ISSUE: Permit to Demolish/Capsulate (partial) and Certificate of Appropriateness for alterations

LOCATION: Old and Historic Alexandria District
115 South Union Street

BAR#2023-00527 & BAR#2023-00528
115 S Union Street

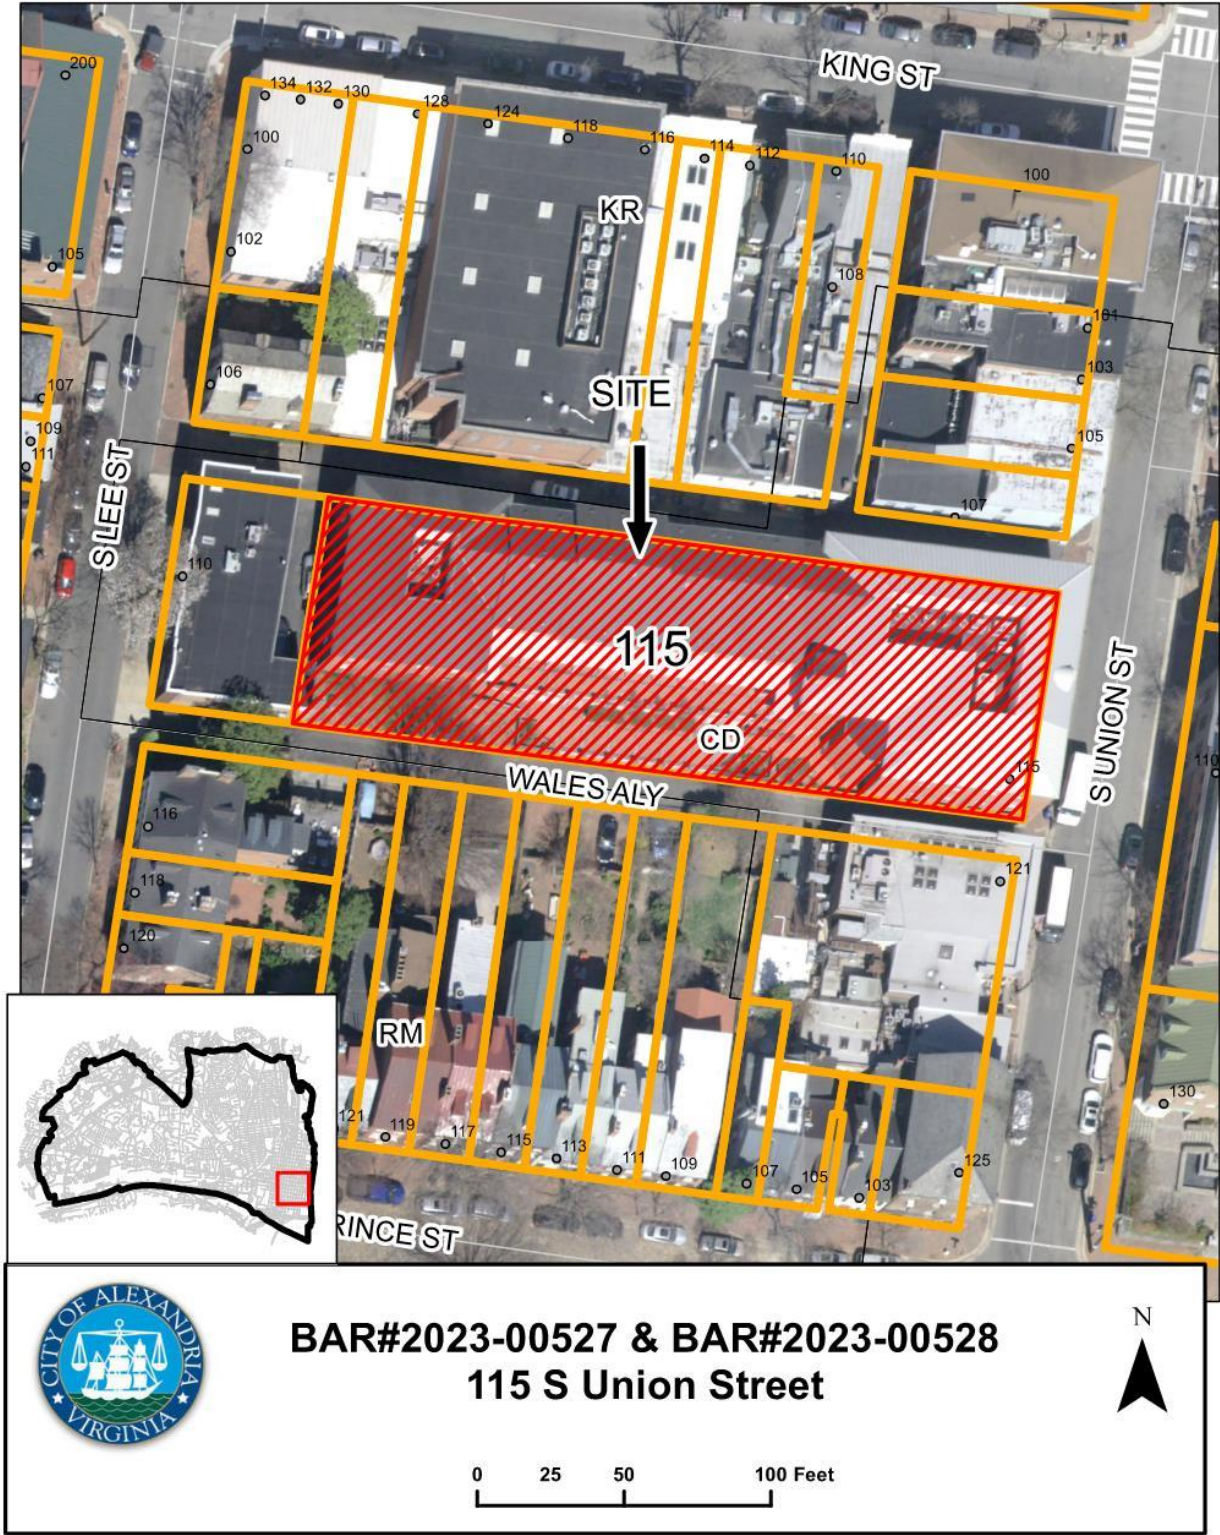
Mr. Scott asked why the architect didn't replicate the storefront windows on the primary elevation instead of replicating the upper floor windows. Ms. Escobar noted that they were making the proportions correct and adding sufficient lighting.

Mr. Spencer felt that the first-floor windows on the first level of the north elevation should be aligned at the top.

Ms. Zandian agreed with Mr. Spencer regarding the window heights on the north elevation.

Mr. Scott also agreed with that suggestion and felt that the fenestration/pattern of the glass should be altered to better go with the storefront windows on the east elevation. In general he supported the application to add windows.

Mr. Adams agreed with the comment about alignment, felt the proposed windows weren't cohesive. He preferred that they match the eight windows above. He suggested a restudy.

Ms. del Ninno agreed that lowering the head would change the window configuration and that it would be a good move to look at the first-floor storefront and tie the first floor together.

Mr. Lyons did not have an issue with the appearance but respected his colleagues' input. He could support the application if the windows were lowered.

The Board felt that lowering the proposed windows to align with the other windows would lead to necessary changes in design which they would like to review at a later hearing.
